PUBLICATION INDEX FOR SGS 1-35

K & L SOARING, LLC
5996 STATE ROUTE 224
CAYUTA, NY 14824

BULLETIN NO. SA-001.6*

SUBJECT: ONE-TIME INSPECTION OF TOW RELEASE ASSEMBLY; DAILY INSPECTION OF TOW RELEASE ASSEMBLY; PILOT'S PREFLIGHT INSPECTION OF TOW RELEASE ASSEMBLY; 100 HOUR/ANNUAL INSPECTION OF TOW RELEASE ASSEMBLY.

FIGURE 1 – ENGAGEMENT OF TOW HOOK INTO RELEASE ARM

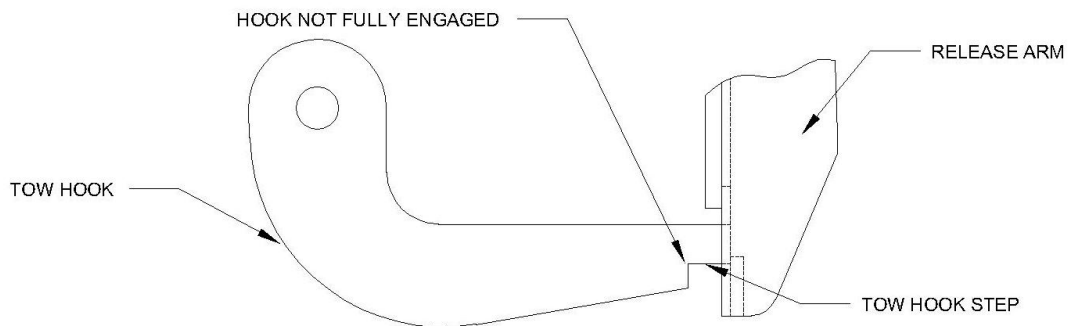
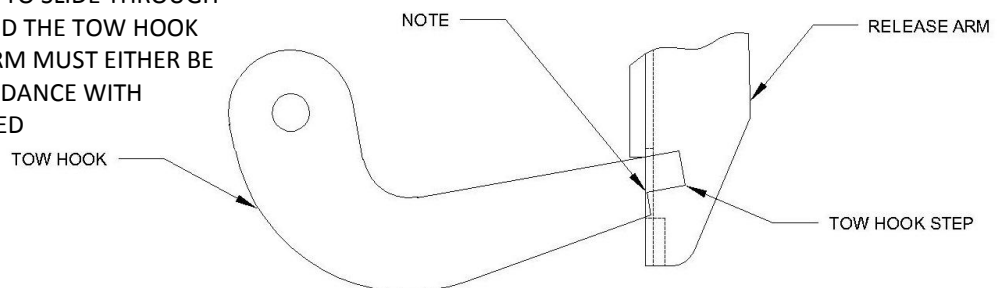
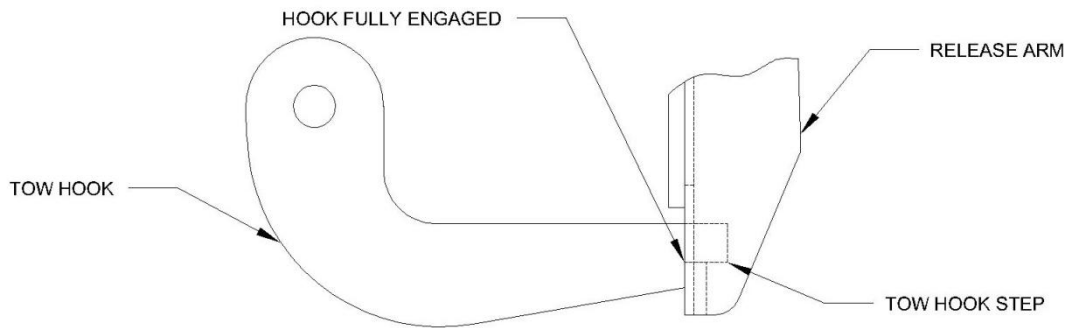
OVERVIEW: The .5 revision is the same as the .4 revision except changes to Figures 1, 3, & 4. Figure 1 has changed to add View D to show improper engagement. Figure 3 has been changed to show proper release arm cutout. Figure 4 has been changed to show proper readings for the C.G. hook install.

- Proper engagement of the tow hook into the release arm is shown in Figure 1, View A, and Figure 4. Excessive wear of the tow hook step could result in improper engagement. Figure 2 of this bulletin provides inspection data and wear limits for the tow hook. Tow hooks which do not meet the specified limits must either be reworked to obtain dimensions (as specified in Figure 2) or replaced.
 - If tow hooks is able to slide into the release arm, beyond the tow hook step, as shown by Figure 1, View C, the release arm must either be reworked with a slug as specified in Figure 3, or replaced.
- c. Inspect tow hook for wear in accordance with Figure 2 of this bulletin.

- Figure 1 shows the proper attachment of the tow hook into the release arm. Note that the step of the tow hook should seat against the release arm. The tow hook step must fully engage the release arm to allow the release assembly to function properly. The tow hook must not be allowed to extend through the release arm beyond the step on the hook as shown in Figure 1, View C.

- g. If tow hook is able to travel too far inboard as shown in Figure 1, View C, disengage tow hook from release arm and measure the length of the release arm slot
- h. If dimension is less than 0.66 inch, rework release arm by welding on 1B-217-19 slug at location shown in Figure 3. (Release arm may be replaced as an alternate to welding on slug)
- i. If length of release arm slot is greater than 0.66 inch, replace release arm.
- j. Perform a thorough inspection of the tow hook installation in accordance with the 100 hour inspection requirements listed in Table 2 of this bulletin.
- k. Repair or replace unserviceable component(s), as required
- l. Record compliance with Part I of this Service Bulletin in Aircraft Log Book.

IF TOW HOOK IS ABLE TO SLIDE THROUGH RELEASE ARM, BEYOND THE TOW HOOK STEP, THE RELEASE ARM MUST EITHER BE REWORKED IN ACCORDANCE WITH FIGURE 3, OR REPLACED

FIGURE 4 - PULL TEST OF TOW RELEASE ASSEMBLY

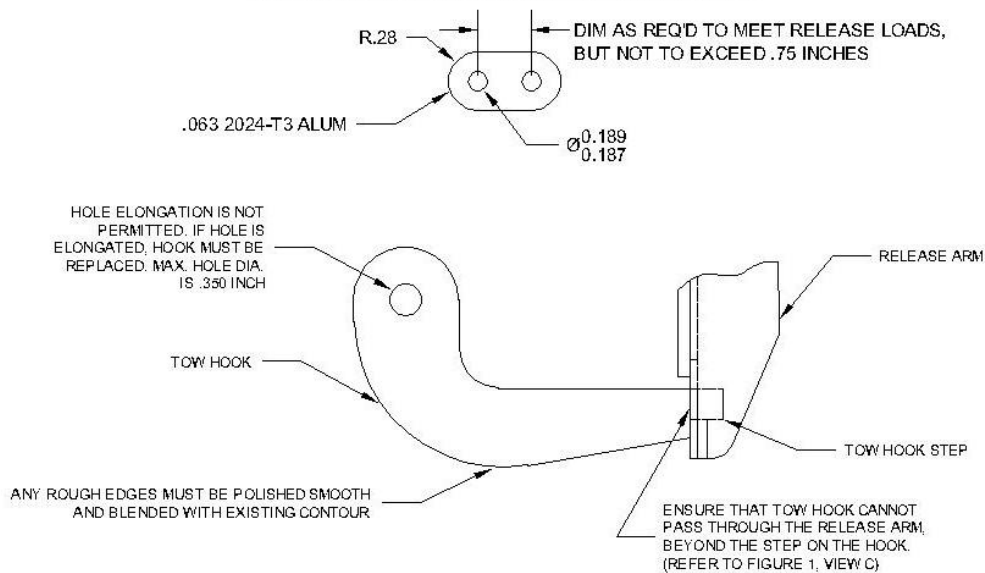
Perform a release check for proper release tension in accordance with Figure 4.			X
Lubricate attach hardware for tow hook and release arm.		X	X
Lubricate guide-tubes in release control with dry stick type lubricant.		X	X
Insure that tow hook moves freely on pivot bolt.	X	X	X

NOTE: IF RELEASE LOADS ARE TOO HIGH WITH C.G. SYSTEM IT IS PERMISSIBLE TO ADD A LINK TO SHORTEN STD 1A141-2 SPRING. LINK SHOULD BE MADE AS SHOWN BELOW. IF REQUIRED THEY SHOULD BE ADDED TO BOTH RELEASE ARMS TO BALANCE BOTH RELEASE SPRINGS

FIGURE 1

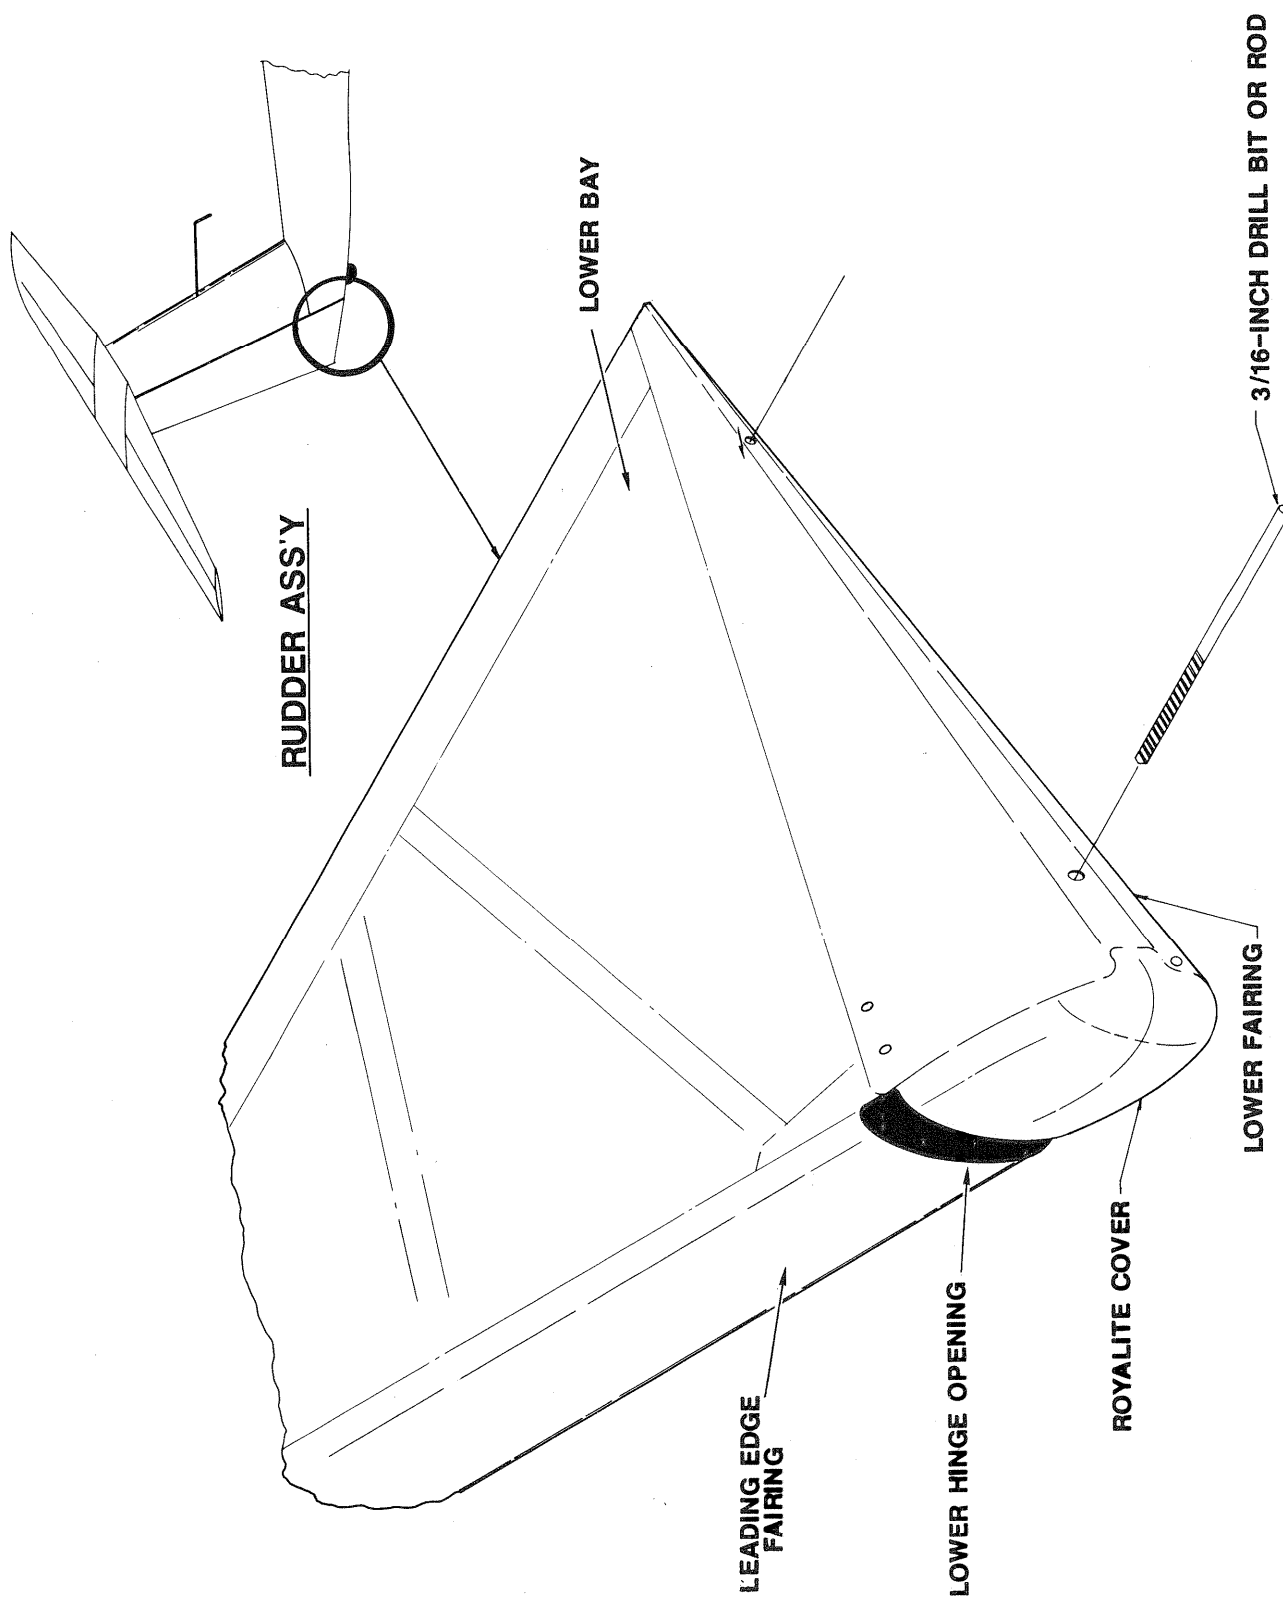
- b. Inspect all hinges, air vents, and aircraft openings for straw, weeds, sticks or any other obstructions. Pay particular attention to hinge and pushrod openings around the tail fin, tail rudder and elevators. Remove obstructions as required.
- c. Inspect for debris inside of tail rudder lower fairing (Figure 1) as follows:

- (1) Carefully adjust rudder position to extreme left or right.
 - (2) Using a flashlight, inspect for debris inside lower fairing (Figure 1) by looking through lower hinge opening.
 - (3) If debris is found, use a vacuum cleaner with flexible extension hose to remove debris.
 - (4) Check two drain holes (Figure 1) at bottom of fairing for obstruction. Clear obstructions with 3/16-inch drill bit.
- d. Open access door on horizontal stabilizer stub (Figure 2) and use a flashlight to inspect upper fin and stabilizer stub area for debris. Use vacuum cleaner to remove debris.
- e. Inspect brake/wheel area for obstructions. Remove obstructions as required.

FIGURE 2

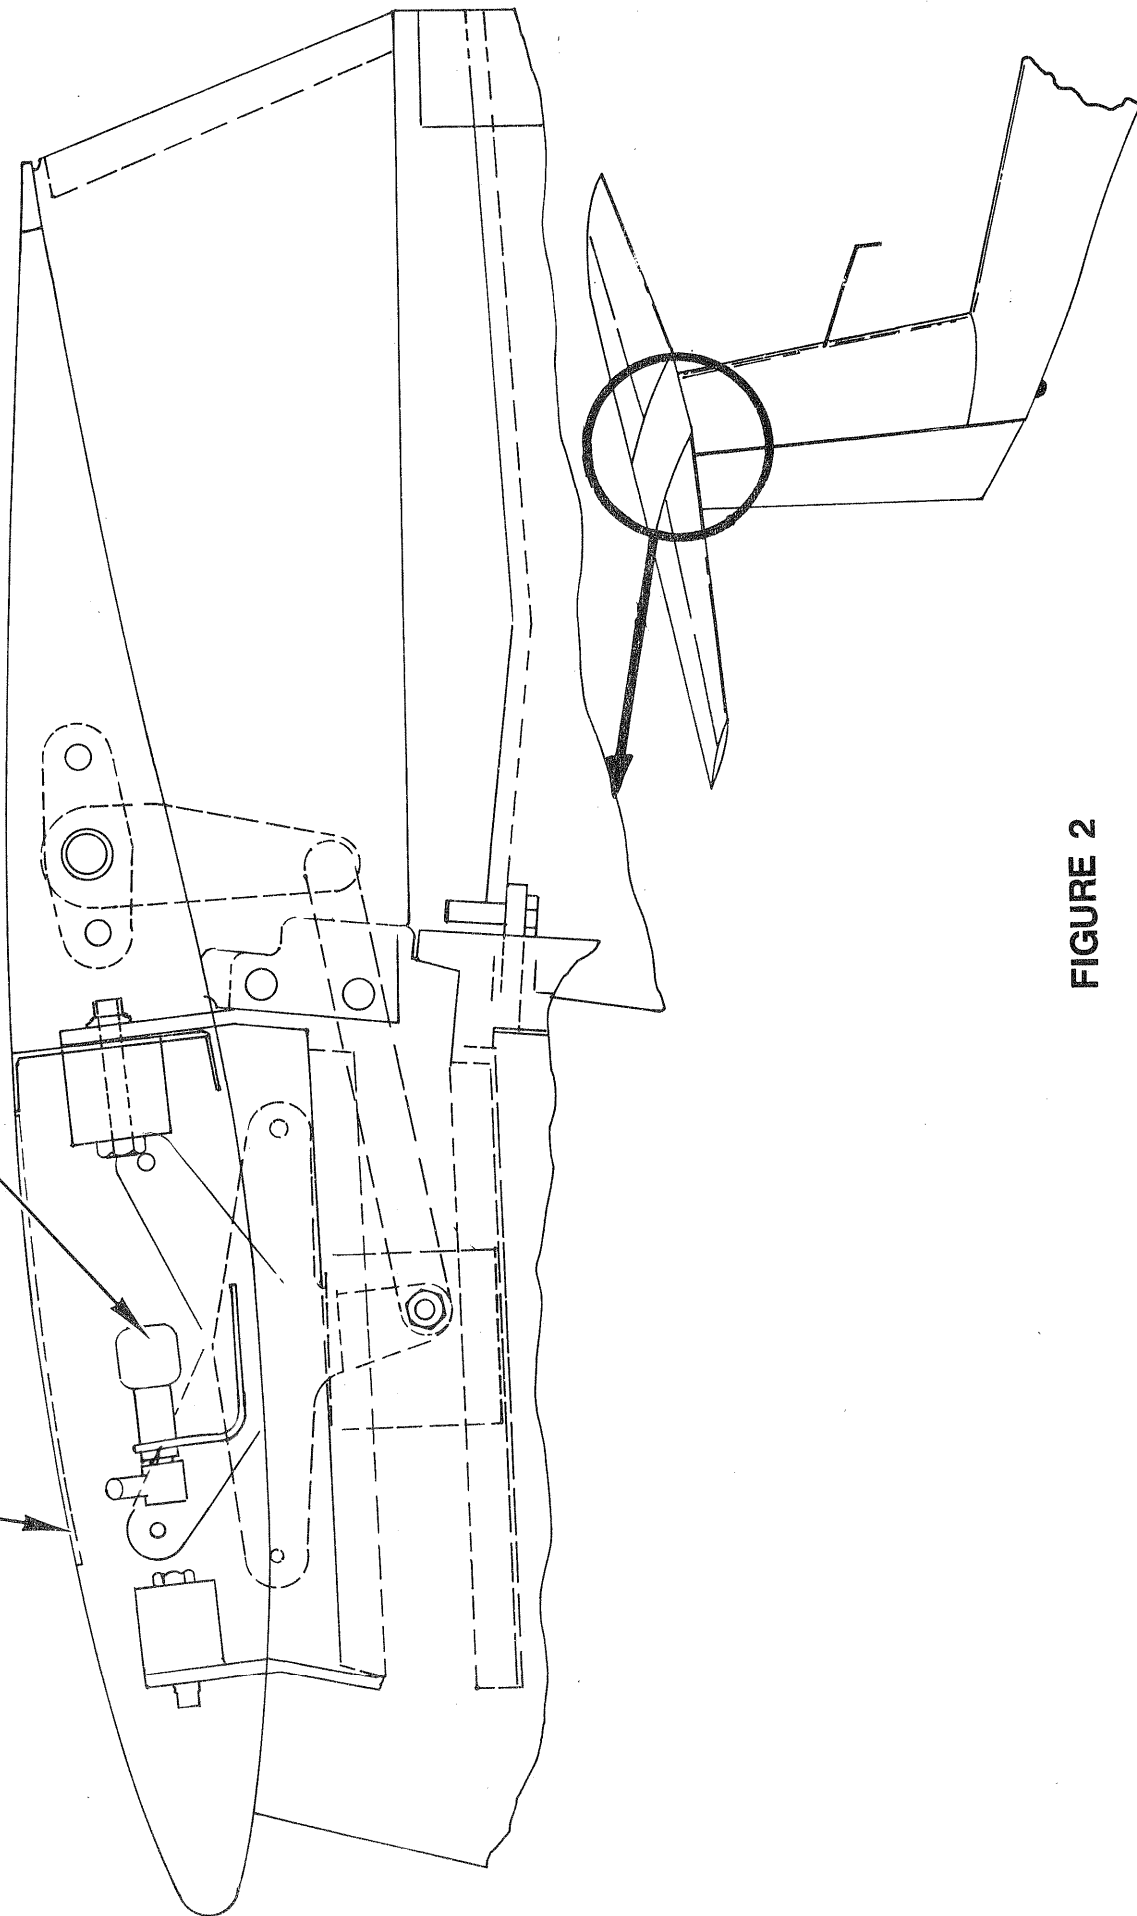
- h. Remove elevators from tail fin as follows:
 - (1) Open access door (Figure 2) on horizontal stabilizer stub.
 - (2) Remove pin securing elevators. (Refer to Figure 2.)

FIGURE 3

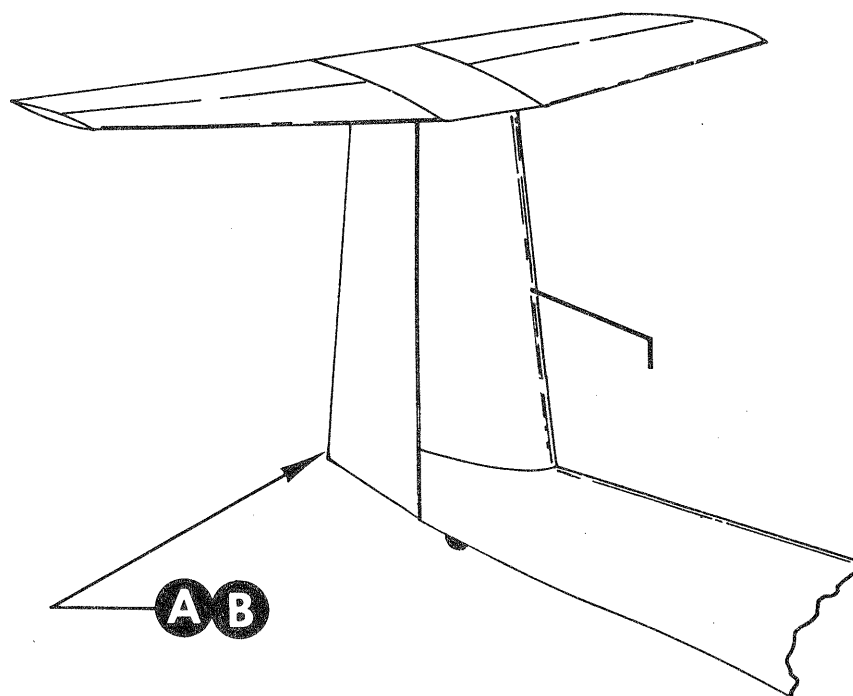
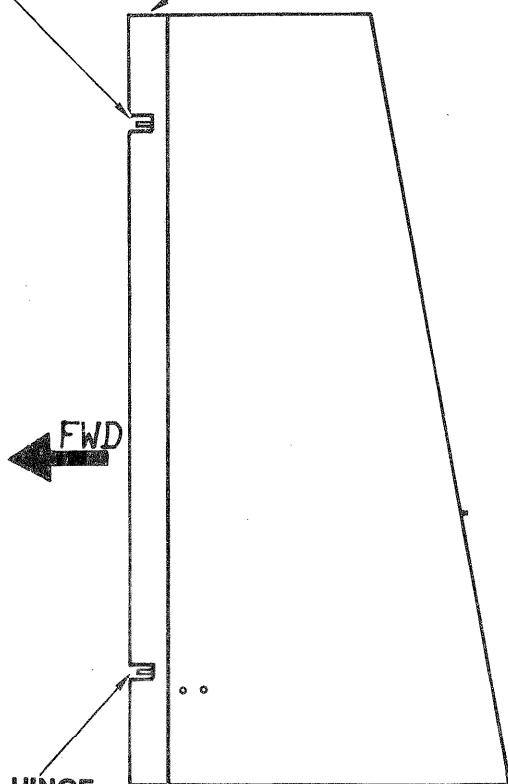
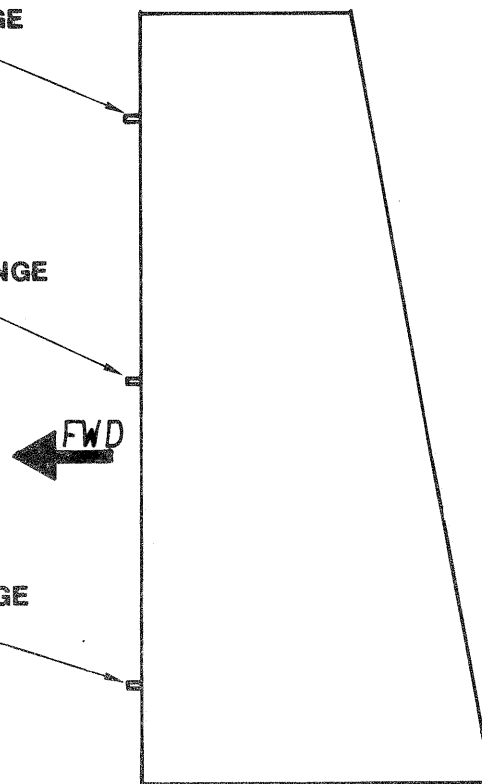
One of two types of tail rudders may be installed on the affected aircraft. The earlier type is an unsealed unit without a leading edge fairing (Figure 3, Detail B). The later type is sealed at the leading edge by a fairing (Detail A). Removal of an unsealed rudder is accomplished by performing step a(1) through a(3). A sealed rudder is removed by performing steps b(1) through b(3).

- c. Using a flashlight and inspection mirror, inspect for debris inside of rudder by looking through hinge openings (Figure 3, Detail A or Detail B, as applicable).
- d. If debris is noted between leading edge fairing and spar, remove debris through upper hinge opening, using vacuum cleaner and flexible extension hose.

- a. If an unsealed rudder (Figure 3, Detail B) is installed, remove rudder as follows:
 - (1) Peel off gap tape between rudder and tail fin.
 - (2) Disconnect pushrods at lower end of rudder by removing a cotter pin, nut, washer and bolt from each push rod.
 - (3) Remove cotter pin, nut, and washer from upper, middle and lower hinge bolts at forward end of rudder. Remove hinge bolts.
 - (4) Remove rudder by sliding aft.
- b. If a sealed rudder (Figure 3, Detail A) is installed, remove rudder as follows:
 - (1) Remove cotter pin, nut, and washer from upper hinge bolt. (Do not remove bolt.)
 - (2) Remove four screws securing lower end of rudder.
 - (3) Remove rudder by pulling lower end aft and then sliding rudder upwards off hinge bolt.

FIGURE 4.

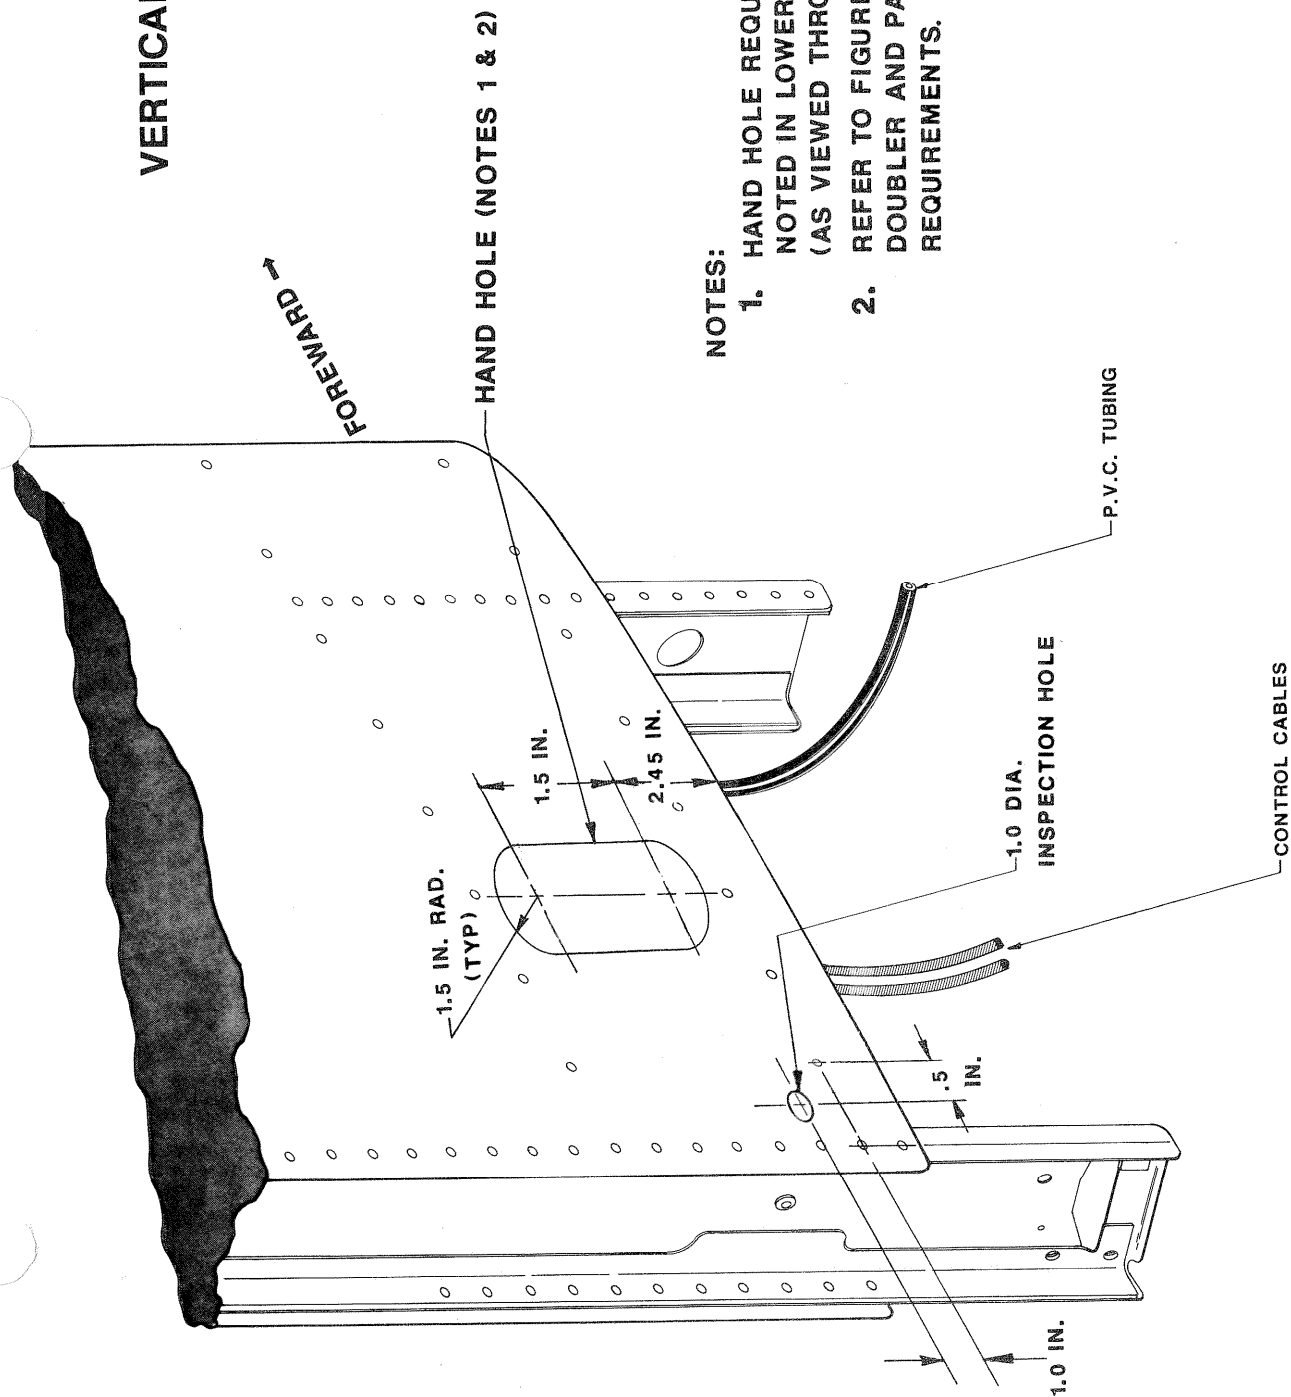
- j. Remove oval shaped inspection holes at aft end of fuselage and inspect fuselage interior for debris. Remove debris as required.
- k. Using 1-inch drill bit and drill, install a 1-inch inspection hole in one side of tail fin at location shown in Figure 4.

- (1) Use drill to puncture skin (of tail fin) and saber saw (or equivalent) to cut access hole at location shown (and size shown) in Figure 4. Deburr edges of access hole.

1. HAND HOLE REQUIRED ONLY IF DEBRIS IS NOTED IN LOWER PORTION OF TAIL FIN (AS VIEWED THROUGH INSPECTION HOLE).
2. REFER TO FIGURE 5 FOR STRUCTURAL DOUBLER AND PATCH INSTALLATION REQUIREMENTS.
